RIGHT OF WAY PLAN OF THE HOLBROOK - SPRINGERVILLE STATE HIGHWAY

PROJECT NO. F-051-1-809

APACHE COUNTY

HOLBROOK — SPRINGERVILLE HWY.
BEAVER DAM WASH — HUNT SECTION
APACHE COUNTY

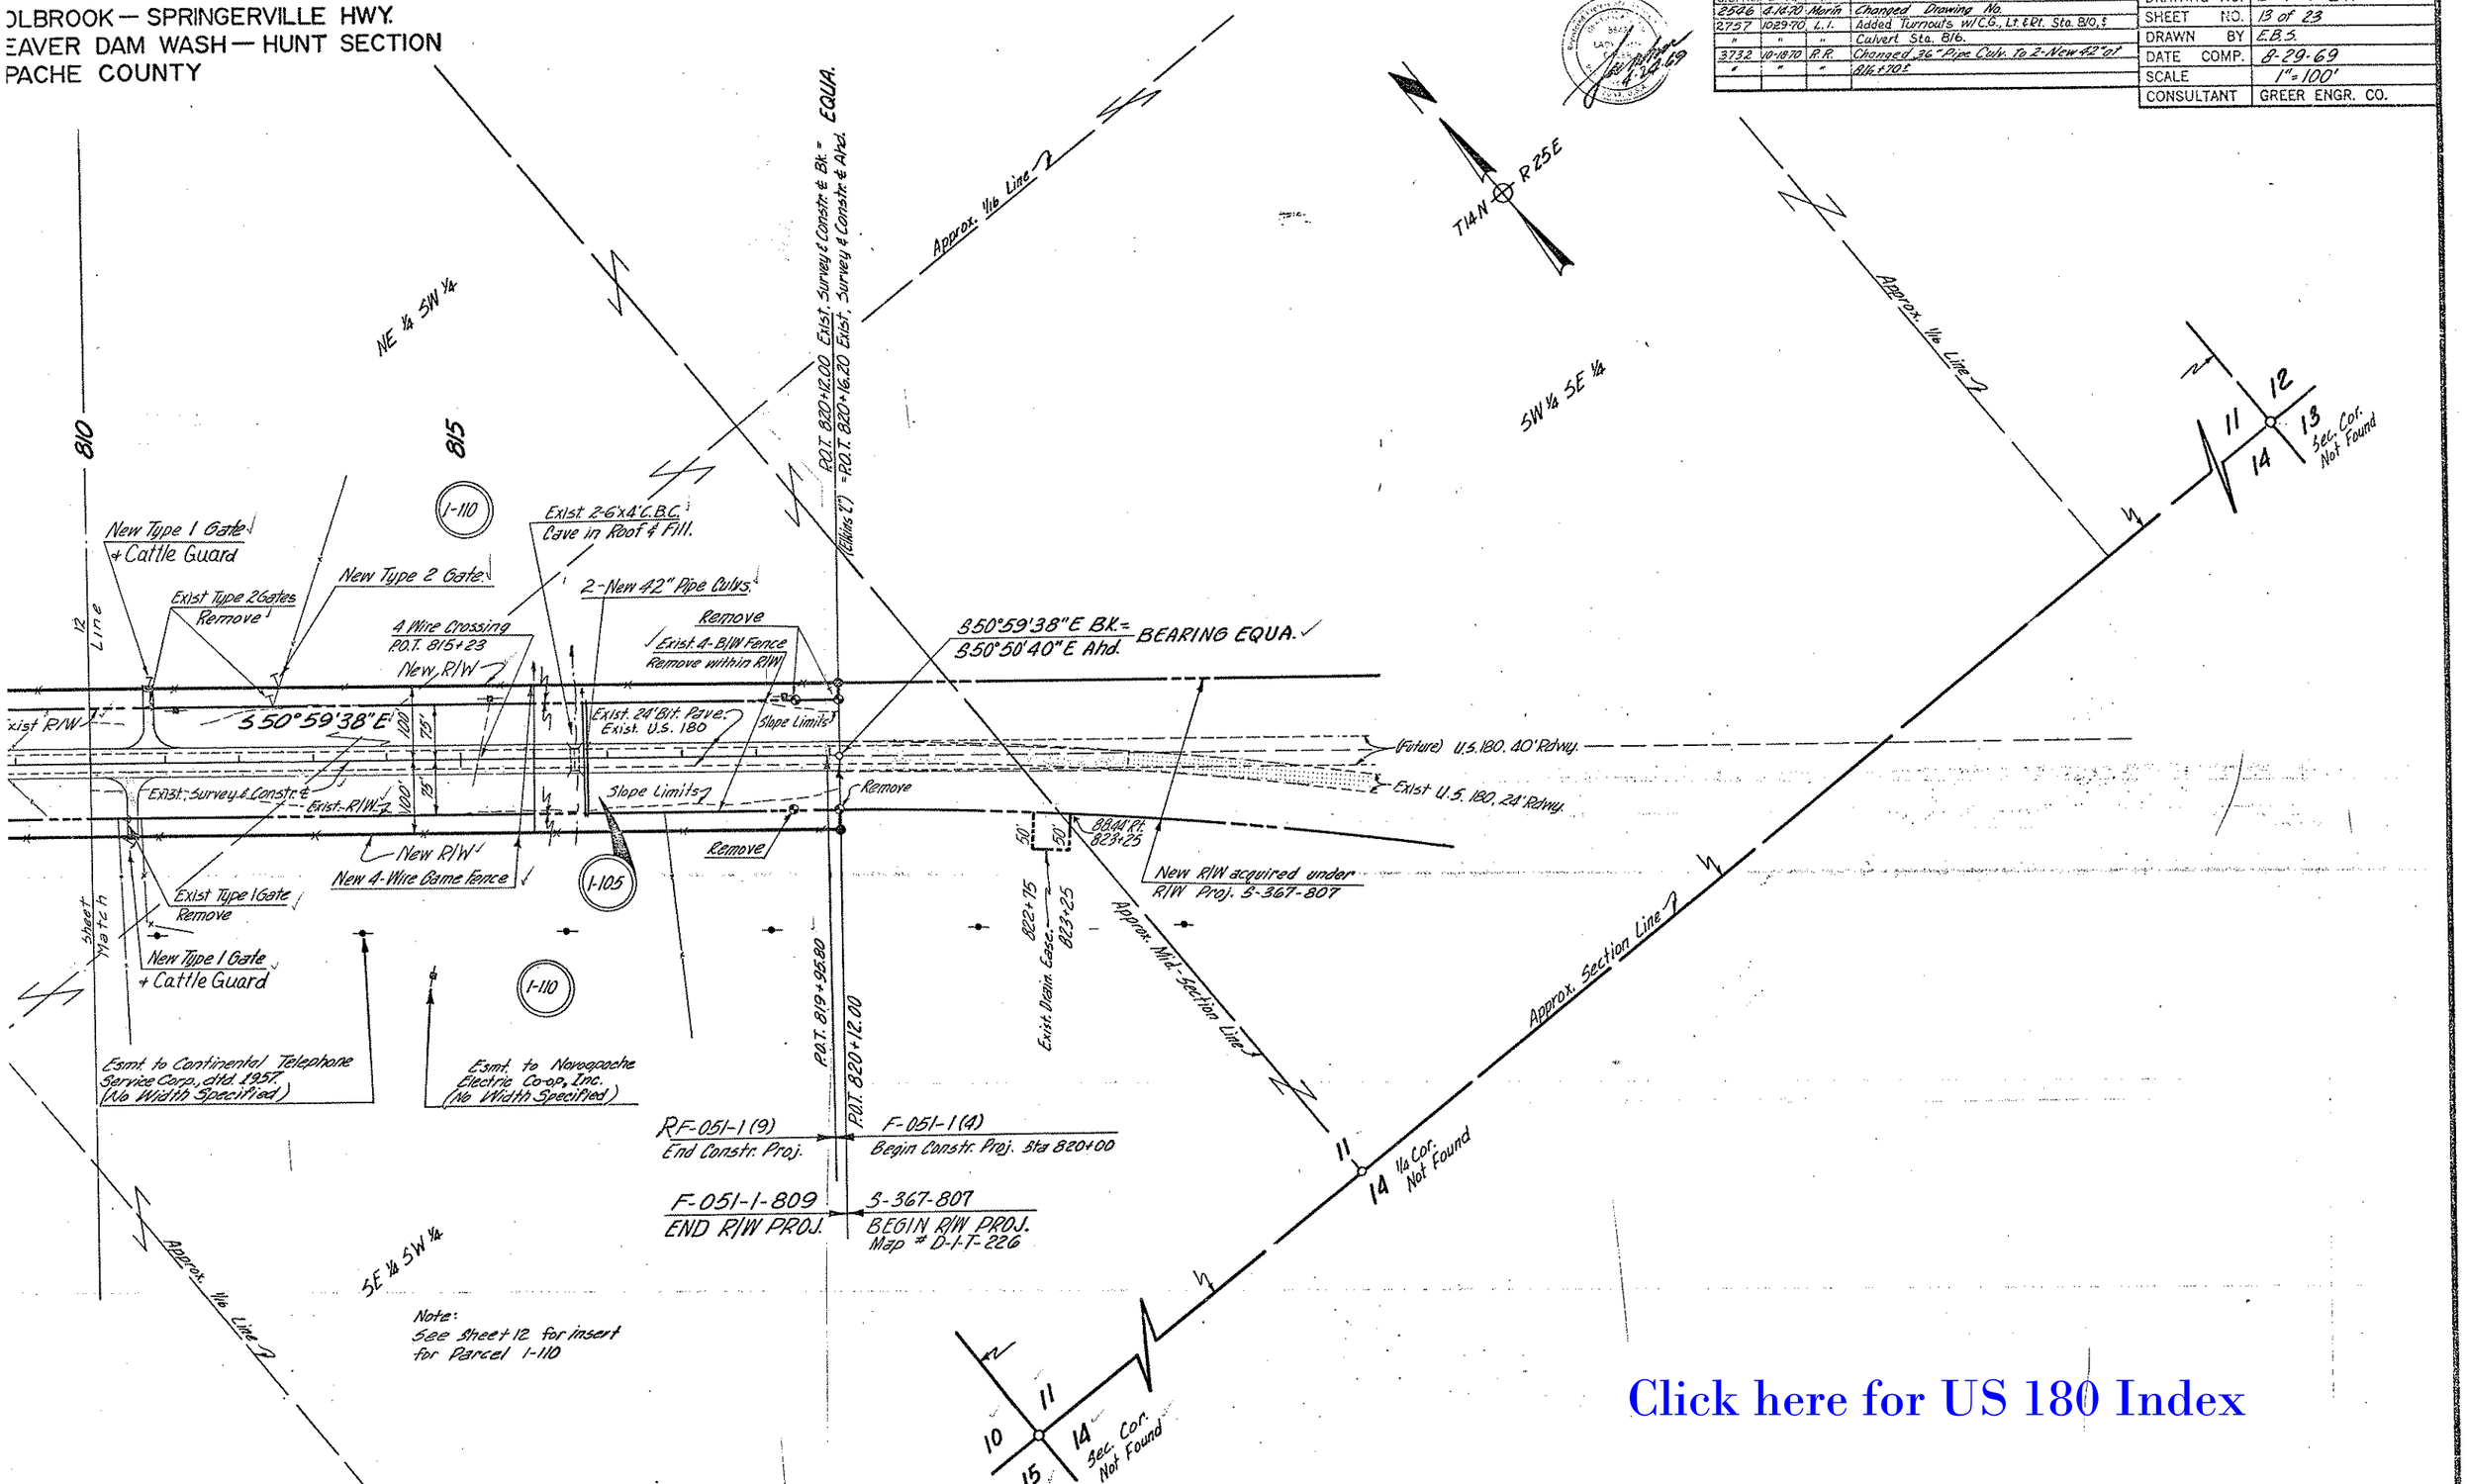
OLBROOK — SPRINGERVILLE HWY.
EAVER DAM WASH — HUNT SECTION
PACHE COUNTY
REVISIONS
C.O. No. | DATE | BY | DESCRIPTION
2546 | 4-16-70 | Morin | Changed Drawing No.
2757 | 10-29-70 | L.I. | Added Turnouts w/C.G., Lt. & Rt. Sta. 810, &
" | " | " | Culvert Sta. 816.
3732 | 10-18-70 | R.R. | Changed 36" Pipe Culv. to 2-New 42" at
" | " | " | 816+70±
PROJECT NO. F-051-1-809
